San Joaquin Solar 1 & 2 Hybrid Project

Complete Response to CEC Data Request

Set #1, 08-AFC-12

(REVISED) SITE PLAN
SAN JOAQUIN SOLAR 1 & 2

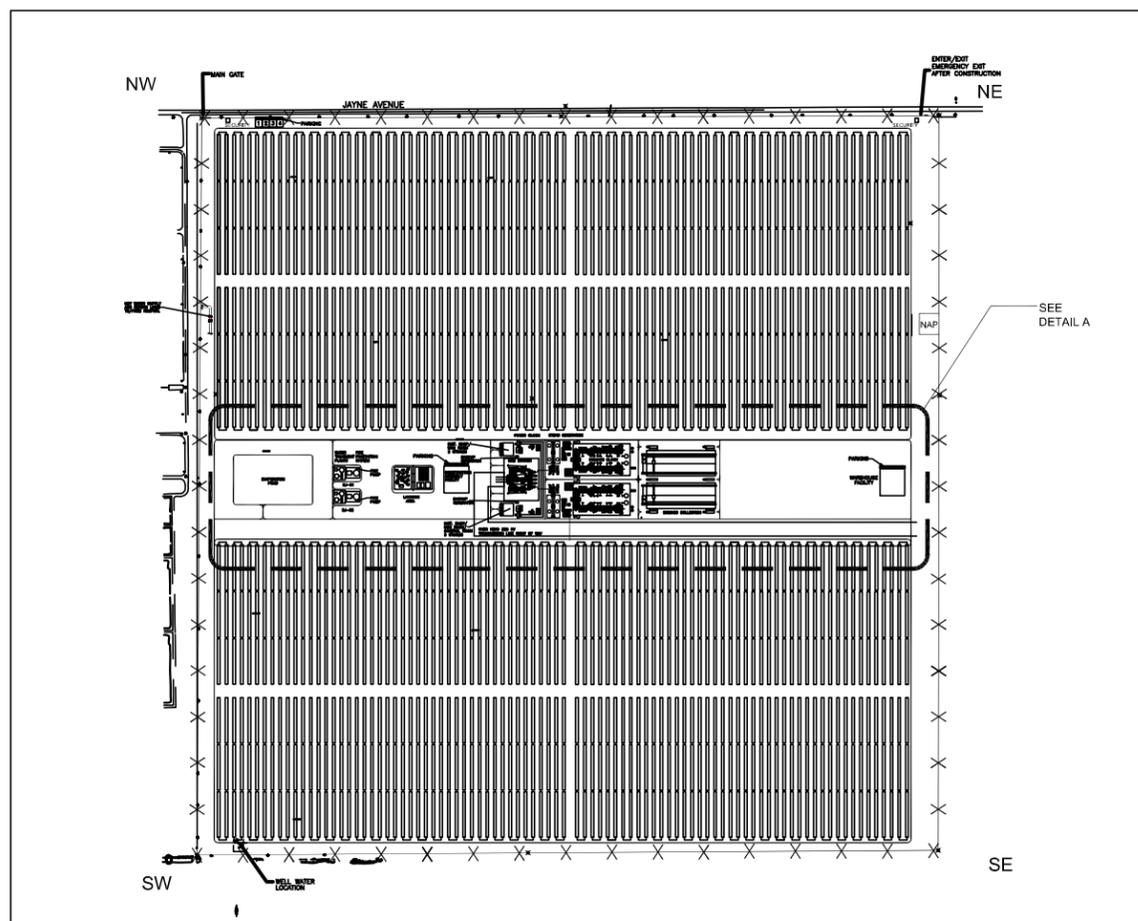
- Reassessed operations equipment and facility design, this included adding one front-end loader and one dust suppression water truck, adding an additional 50 MMBtu/hr natural gas heater to each combustor for cold startup purposes, replacing two 2-cell WSACs with four 2-cell WSACs and revising the locations of buildings on the plot plan.

In the following pages, a revised air quality analysis is presented based on these re-evaluated revisions. It describes the assumptions and general approaches used to estimate emissions from the project operational and construction phases. It also presents revised emission estimates and provides a summary comparison of the new results with those in the AFC. The revised analyses are presented using the same section and table numbering as the AFC. Figure 5.2-2 Revised is also provided with this analysis showing the new site plan and building configurations.

G:\gis\projects\157727658031\support\data\Requests_0509\AI\FigDR-54_Cut_Fill_Plan

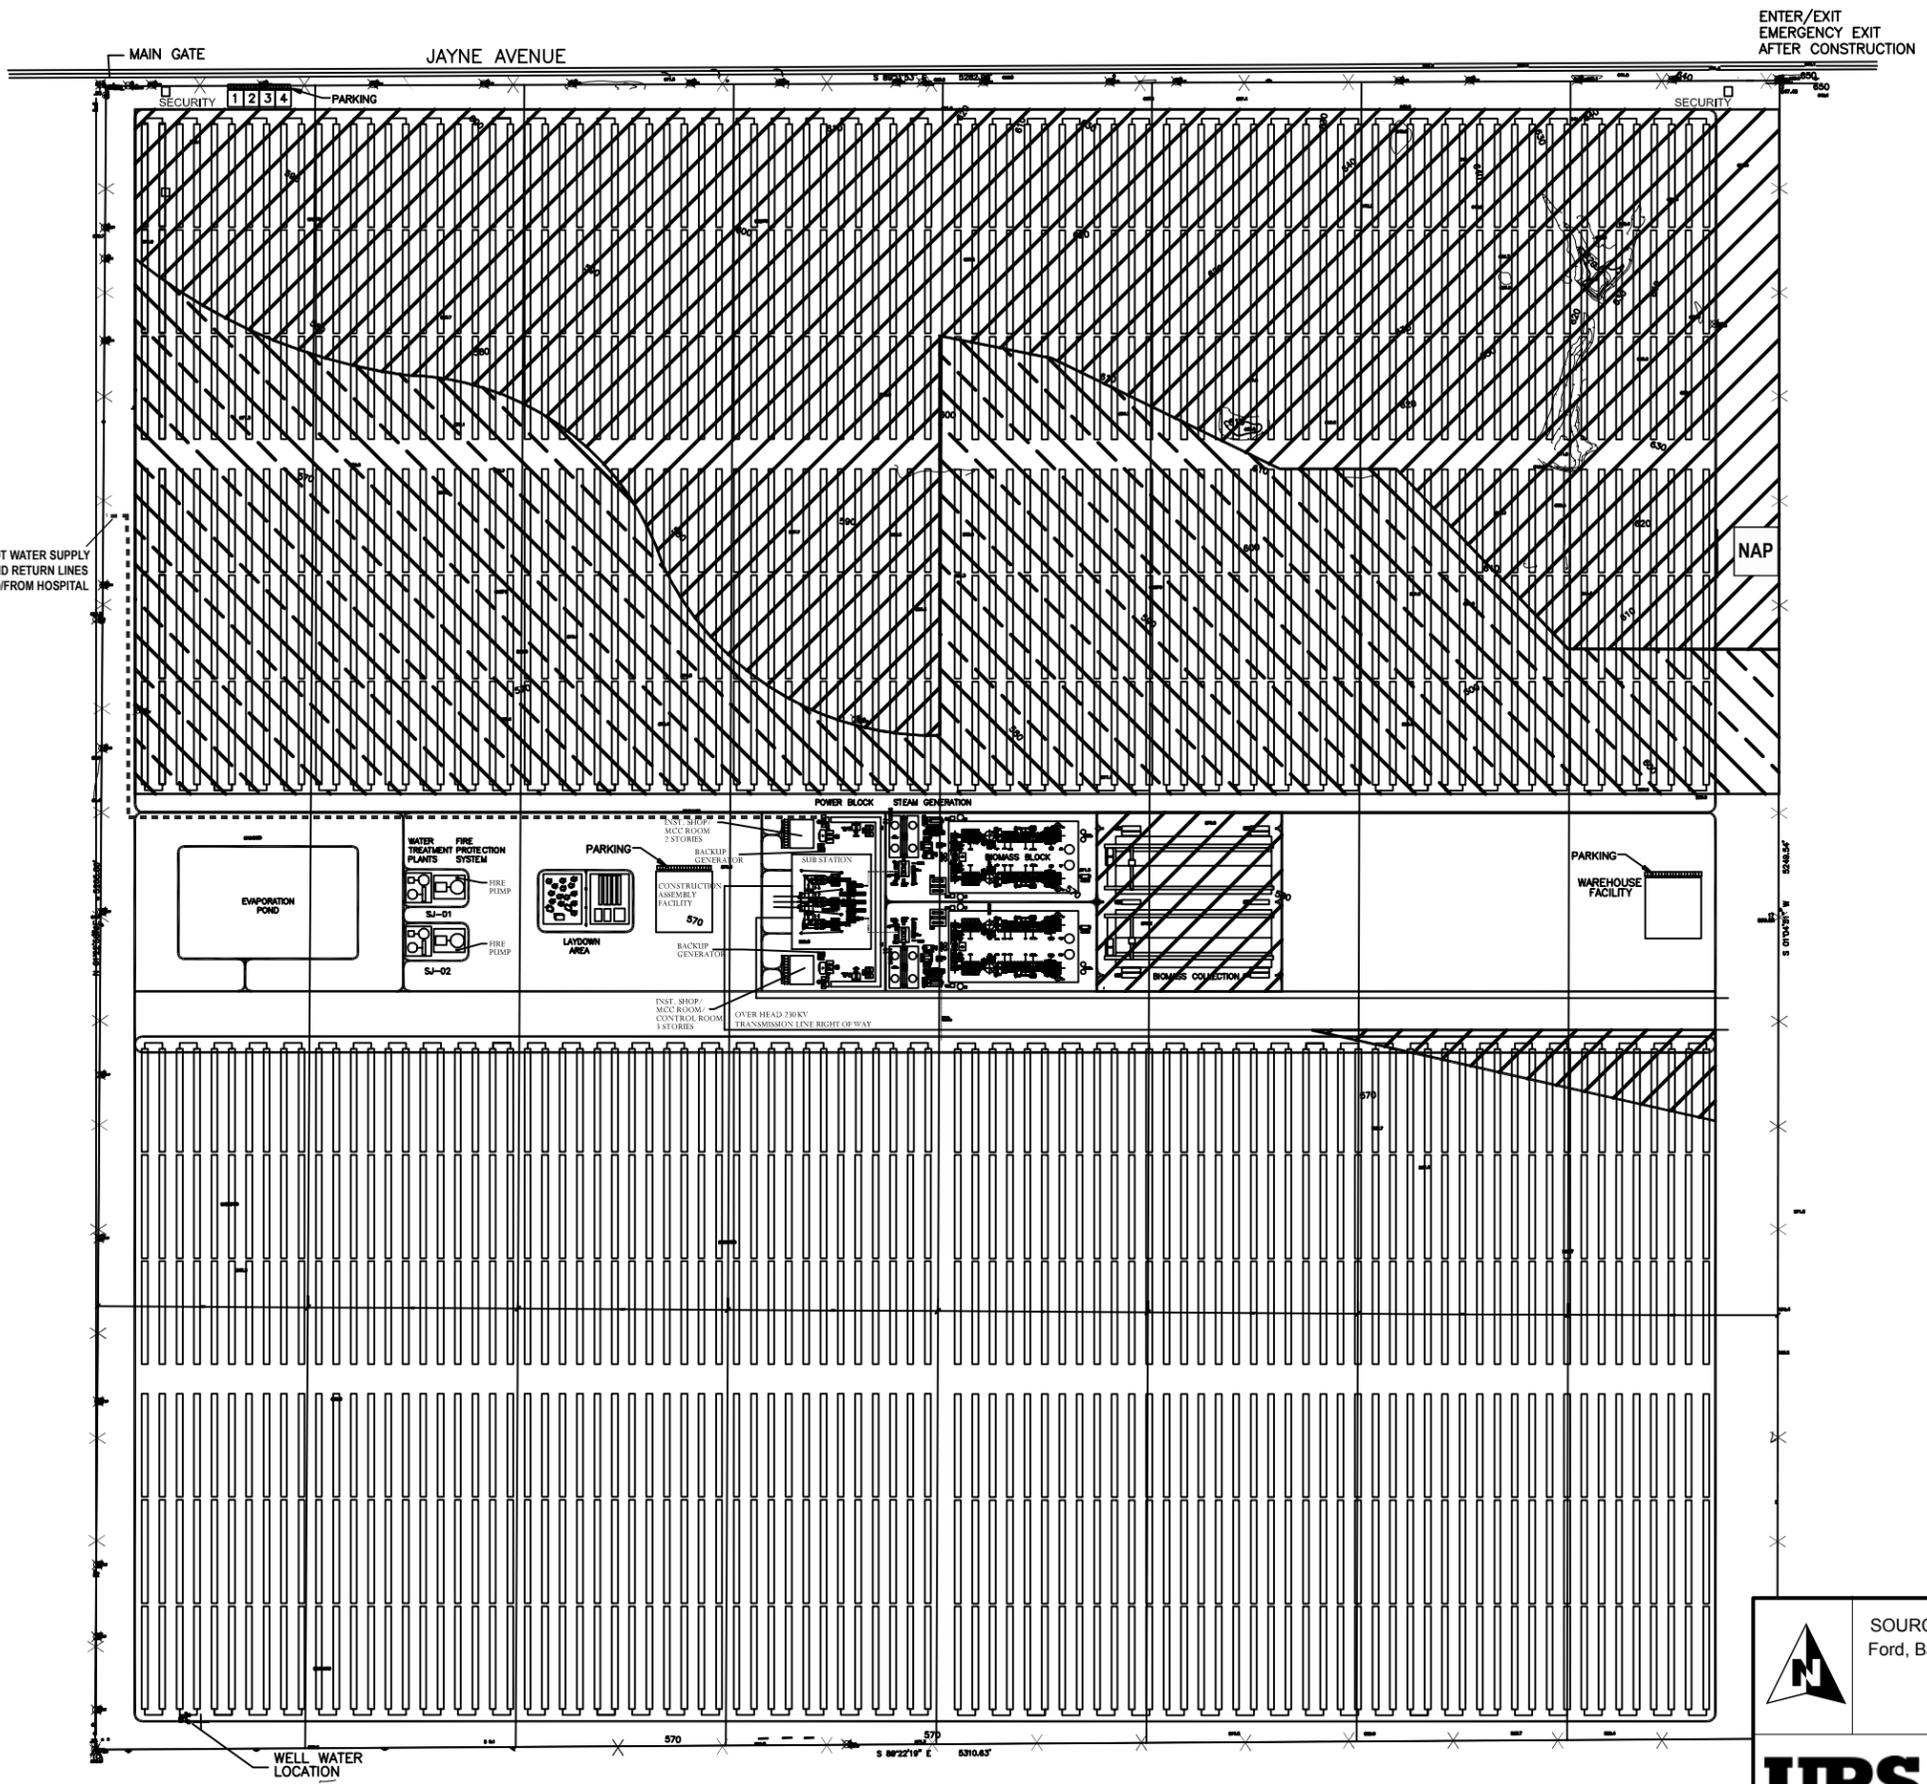
Data Request 54: Please provide a project site plan showing the locations where excavation would exceed three feet below the surface by shading or other such convention.

Response: Please see the attached figure (next page), which details the locations where excavation activities would exceed three feet below the surface.

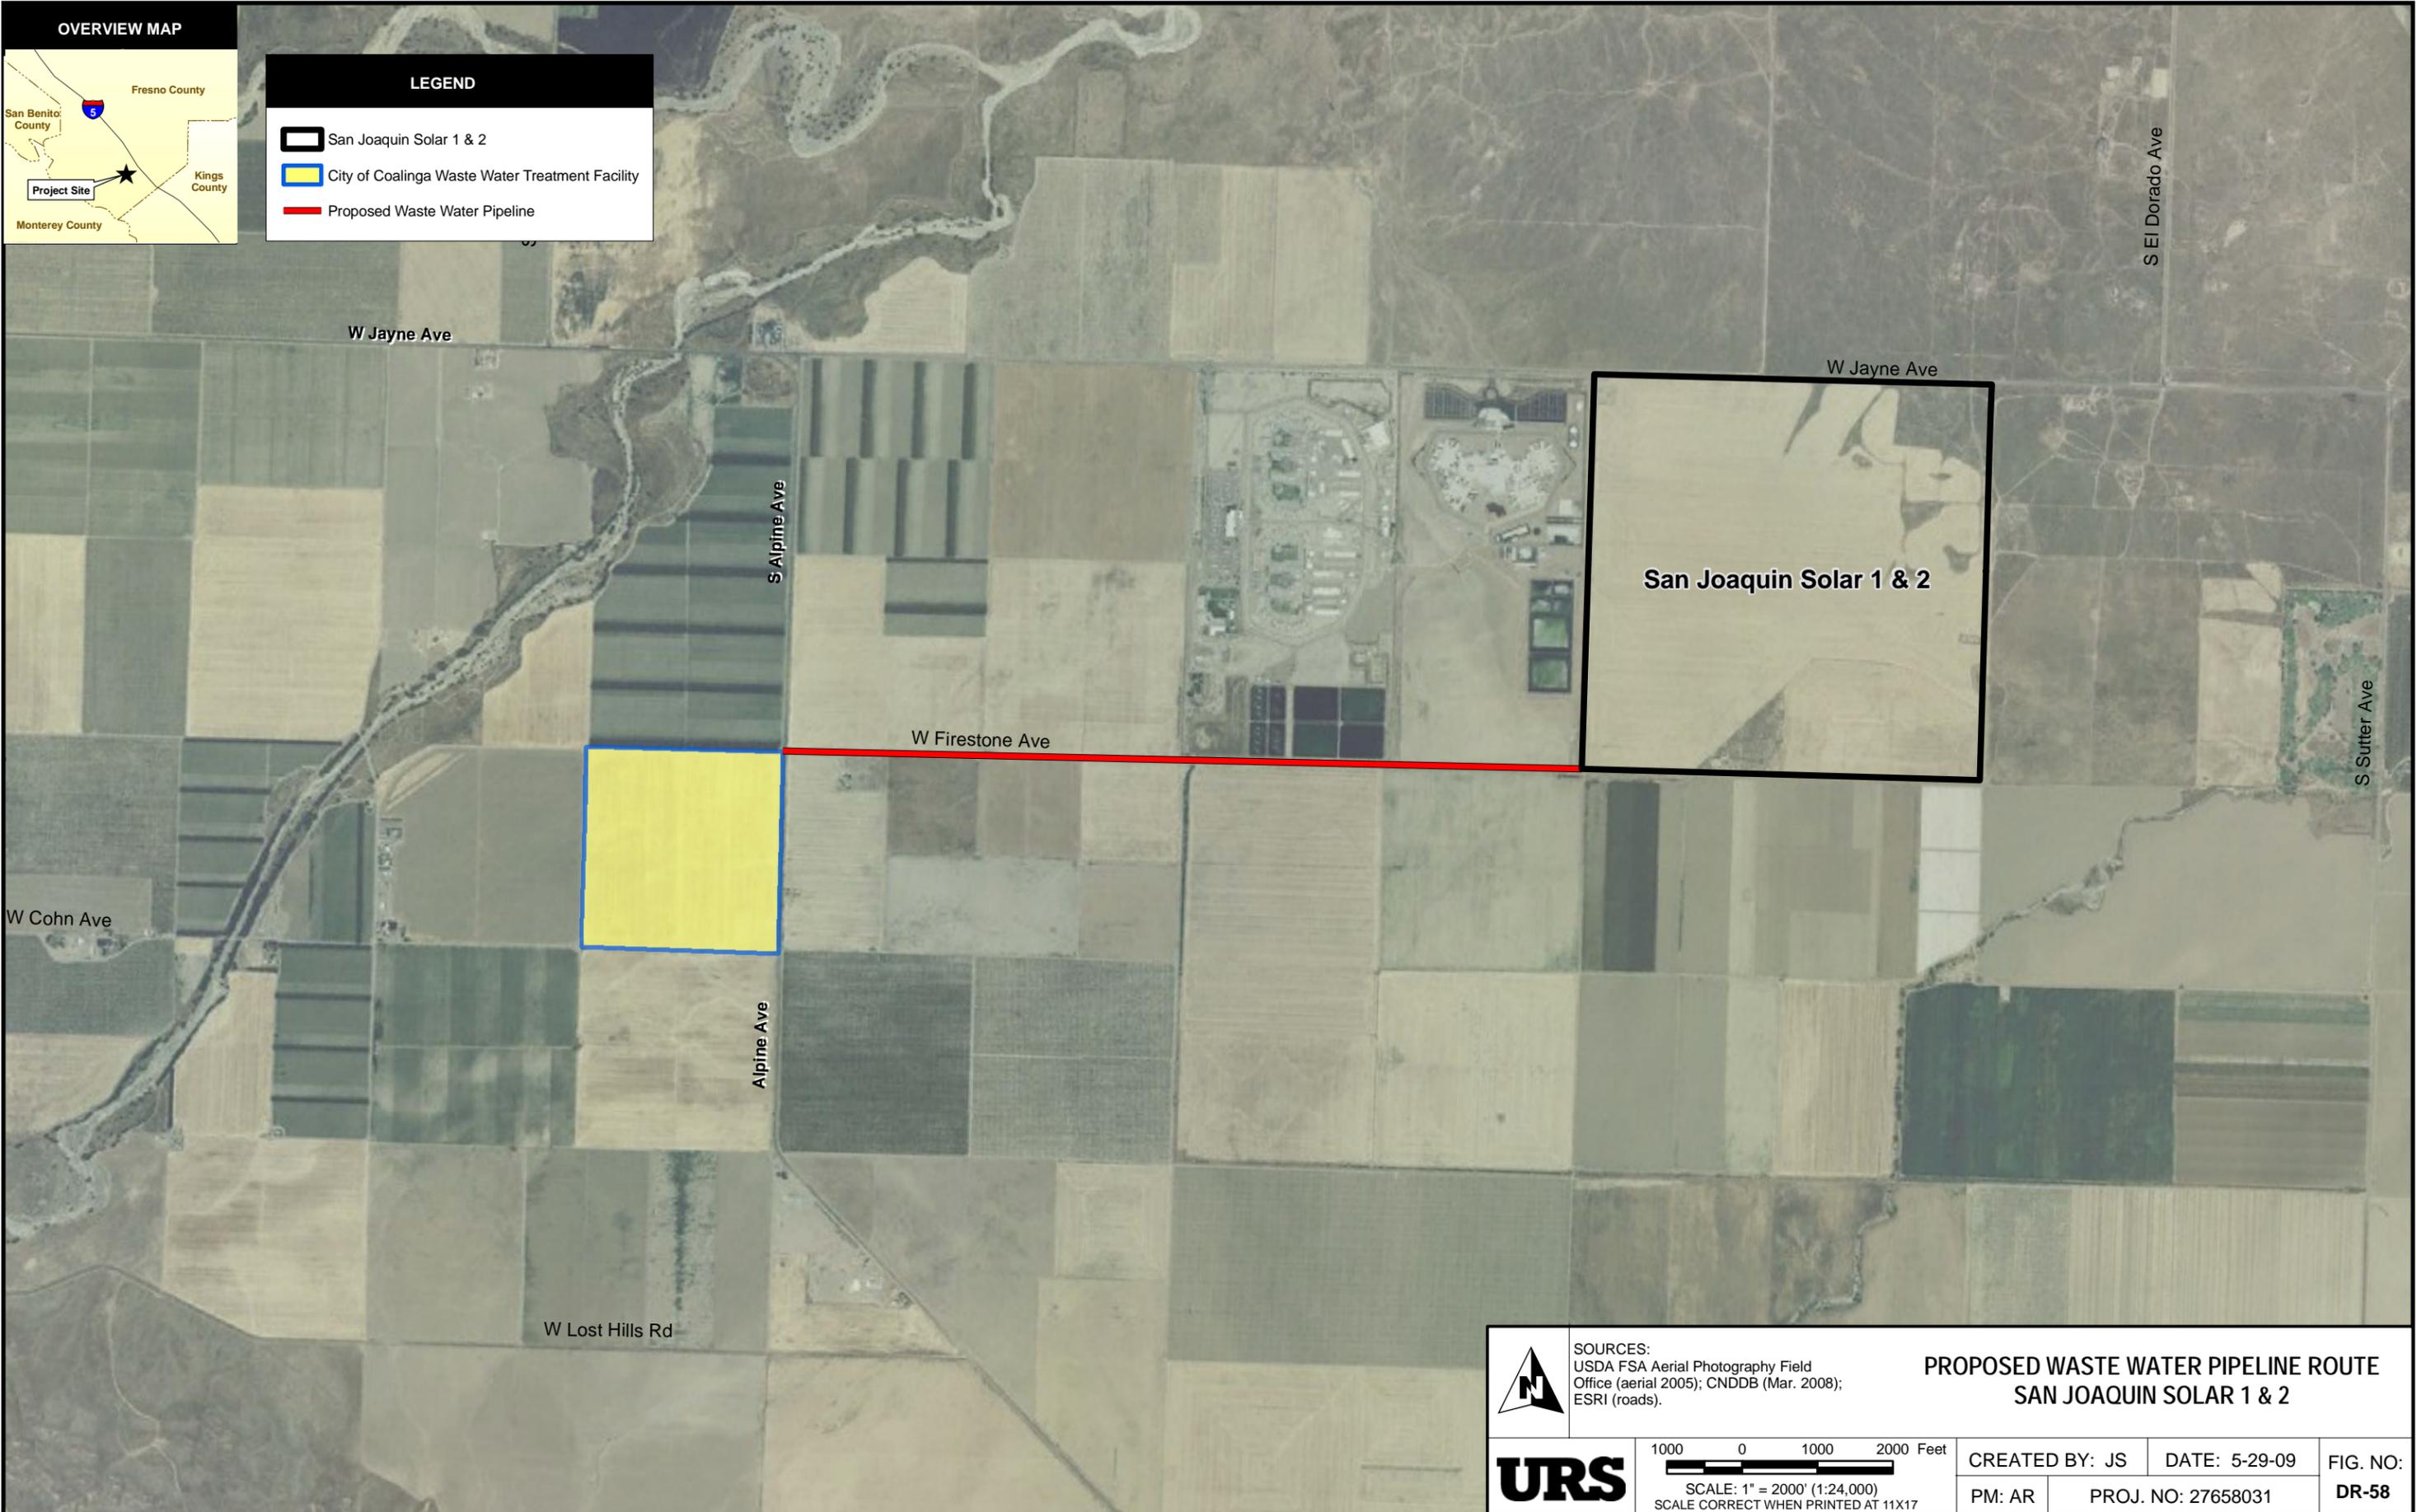
Data Request 59: If the reclaimed water pipeline route and the steam pipeline route have not been surveyed for cultural resources, please have a qualified archaeologist survey these routes and record on Department of Parks and Recreation (DPR) 523 forms any cultural resources that are identified.

REVISED Response: As part of preparation of the AFC and technical report, the route of the water and steam pipelines within the proposed plant site boundaries were surveyed for cultural resources and reported in accordance with the CEC Rules of Practice and Procedure and Power Plant Site Regulations Revisions, Appendix B (g)(2). The route of the reclaimed water pipeline was surveyed on June 15, 2009. A supplemental records search was conducted prior to survey. No cultural resources greater than 45 years of age were identified. Therefore, no Department of Parks and Recreation (DPR) 523 forms were completed.
